MK KASHIYAMA ITEM / INTERCHANGE NEWS

Announcement

No.	Origin	Quotation Month
D2018H	Made in Japan, Indonesia	May, 2025

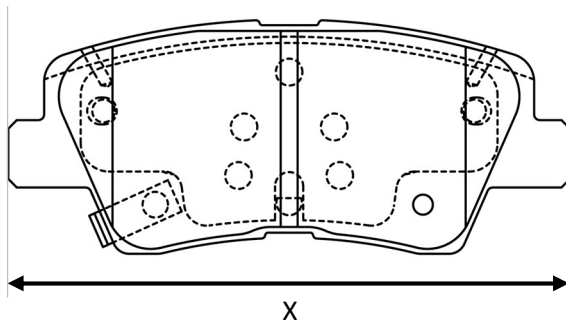
■ Newly start Products with SHIM (Existing MK KASHIYAMA Item)

No.	Origin
D2323M	Made in Japan, Indonesia

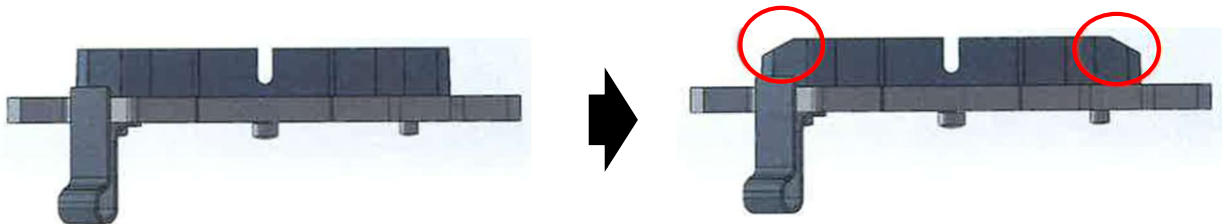
■ Change the shape of lining

We added chemfering for the side edge of lining of below product.

This change will start from July shipment.

<From July shipment>
